The 55 details drawn differently in CAD and Revit

Checked against the new drafters' file, 26 October.

55 of the 190 CAD typical details have a Revit version in your templates that is drawn differently. Each page: your CAD detail on the left, the Revit version on the right, what differs, and one answer: CAD is right, Revit is newer (we update CAD from it), or both wrong.

Your template: TYP. STEEL COLUMN BASE PLATE U.N.O. (Steel R24; on no sheet)

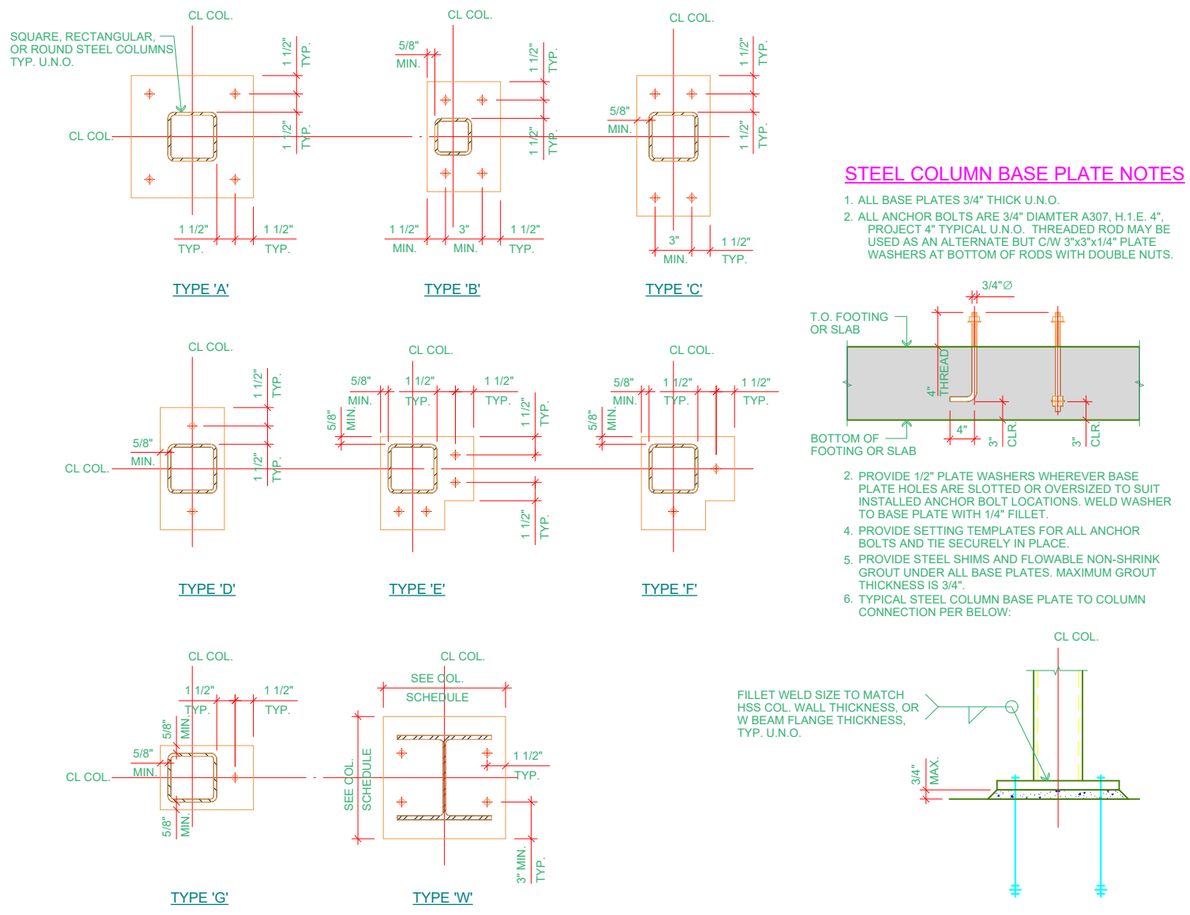
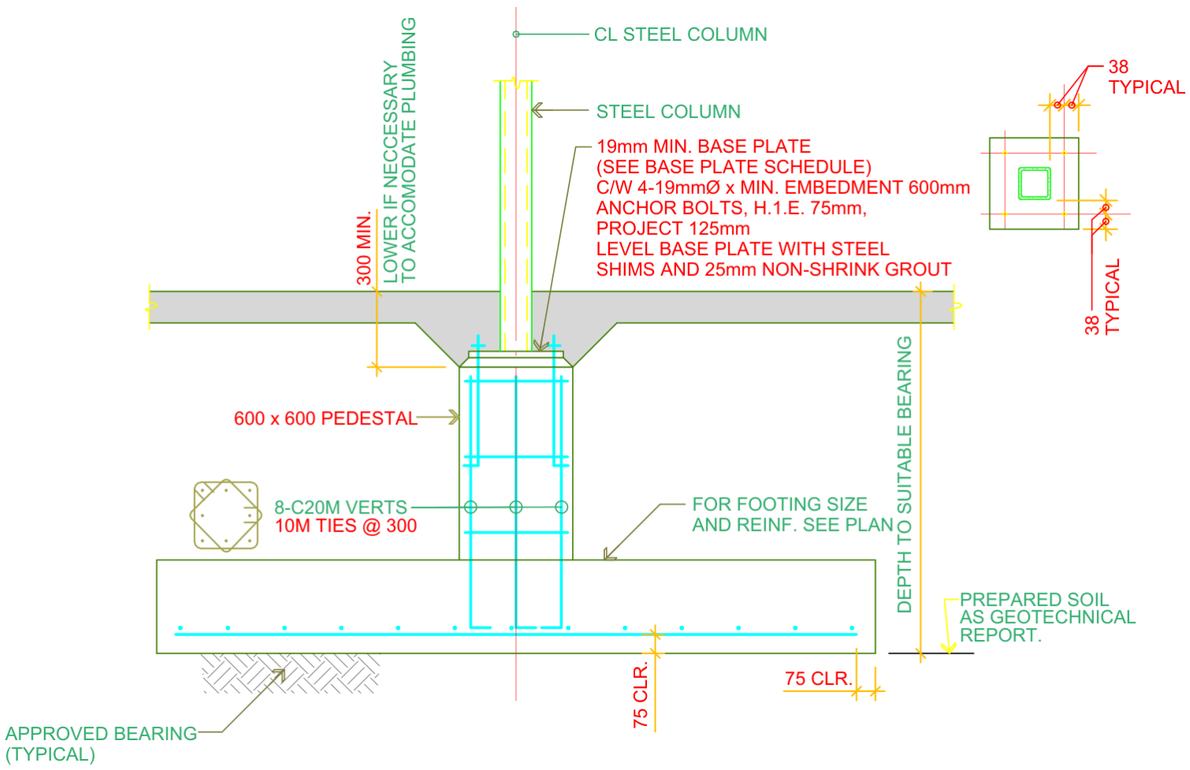
What differs: same 8 types A-G,W, same 6 notes and section, but metric (38/16/75, 19 dia, 25 grout) vs candidate imperial (1 1/2"/5/8"/3", 3/4", 3/4")

Your template: TYPICAL COLUMN BASE AT FOOTING (Steel R24; on no sheet)

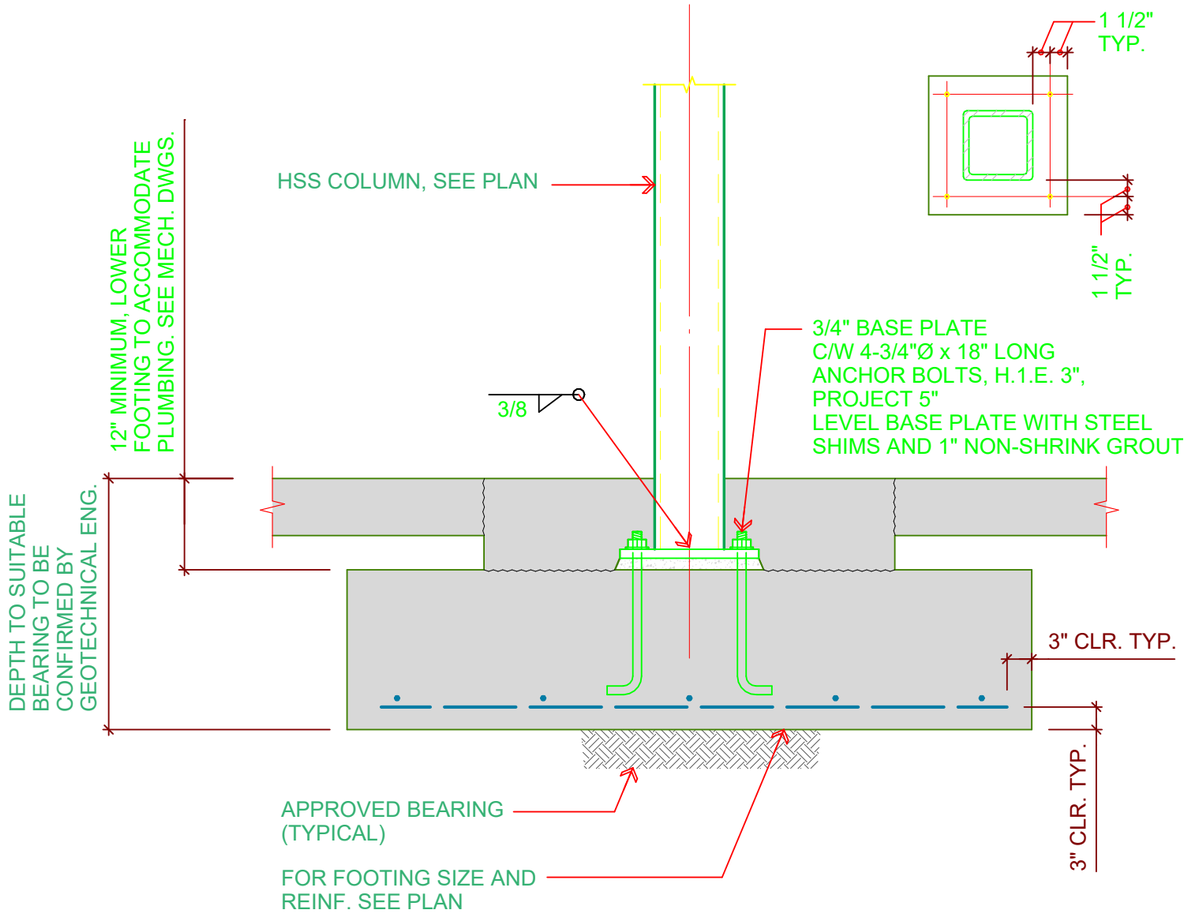
What differs: candidate omits 600x600 pedestal with 8-C20M verts/10M ties@300; imperial (3/4" plate, 4-3/4"x18" bolts, 3" clr); adds 3/8 weld
